JACKSON STREET SUBDIVISION, RESUBDIVISION OF LOT 1, RENEA'S SECOND ADDITION TO JACKSON STREET

APPLICATION NUMBER 6 DATE August 1, 2019
 APPLICANT Jackson Street Subdivision, Resubdivision of Lot 1, Renea's Second Addition
 REQUEST Subdivision

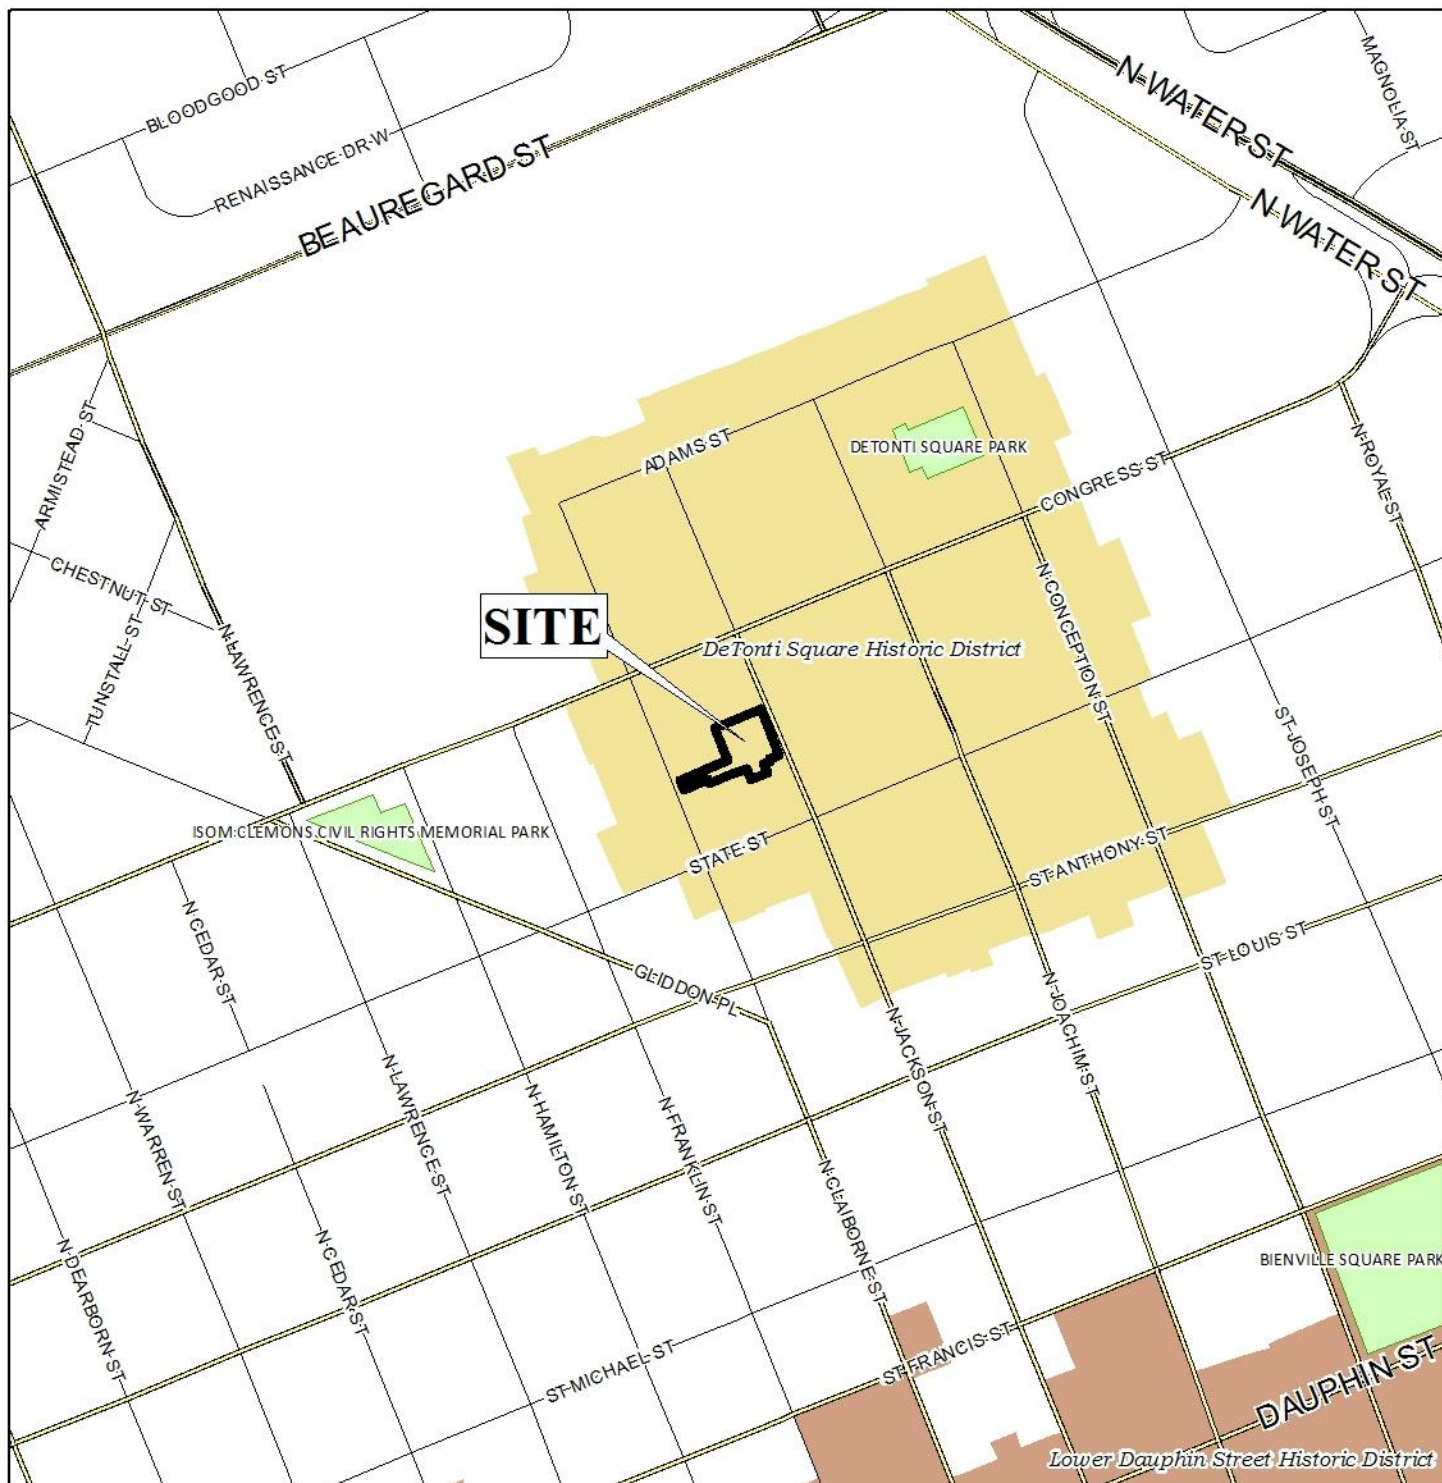
The proposed subdivision fronts Jackson Street and North Claiborne Street. Both are minor streets with curb and gutter. As a minor street, a 50' right-of-way width is typically required. The right-of-way width of Jackson Street, as indicated on the preliminary plat, reflects compliance with minor street standards and if approved, should be retained on the Final Plat. North Claiborne Street depicts a 40' right-of-way width on the preliminary plat. Previous subdivisions along North Claiborne Street, approved by the Planning Commission, have not required right-of-way dedication: this includes property abutting the site. Therefore, right-of-way dedication should be waived for the request at hand.

The proposed lot 1-B abuts two "B" streets, thus the applicant must indicate which street will act as the primary frontage for the lot.

Property width requirements for a T-4, Mixed-Use, Low-Intensity Sub-District, are a minimum of 18' and a maximum of 120' per Section 64-3.I.8.(b).2 of the Zoning Ordinance. The property width is illustrated on the preliminary plat as 85'± for proposed Lot 1-A on North Jackson Street. Lot 1-B will have 21'± of street frontage on North Claiborne Street and 30'± of frontage on North Jackson Street and if approved, should be retained on the Final Plat.

Per Section 64-4.I.8.(d), the DDD allows from 0' minimum to 12' maximum setback along all street frontages. A 12' maximum building setback line is depicted along all frontages on the preliminary plat along with a note stating a 0' minimum is allowed. If approved, both should be retained on the Final Plat

The DDD also requires a 20' parking setback in T-4 Sub-districts per Section 64-3.I.8.(d) of the Zoning Ordinance. The preliminary plat depicts a note indicating that any parking must be 20' from the street property line and, if approved, should be retained on the Final Plat.

The proposed lots exceed the 7,200 square foot minimum lot size requirements for lots served by public water and sanitary sewer systems. The preliminary plat provides the lot sizes in square feet and acres, and if approved, this information should be retained on the Final Plat as well.

There is a 10' maximum driveway width requirement within front setback along primary frontages within T-4 Sub-districts, per Section 64-3.I.11.(c)(3) of the Zoning Ordinance. Any new driveway must comply with this requirement.

As a means of access management, a note should be placed on the Final Plat, if approved, stating that the proposed lots are limited one curb cut each per street frontage, with any changes in the size, design and location to be approved by Traffic Engineering and conform to AASHTO standards.

Based upon the preceding, this application is recommended for Tentative Approval, subject to the following conditions:

- 1) retention of building setbacks to reflect a maximum building setback line of 12' along all streets;
- 2) retention of a note stating that a 0' minimum building setback is allowed;

- 3) retention of a note stating that parking must be setback 20' from the property line;
- 4) retention of the lot size information on the Final Plat to be depicted in square feet and in acres;
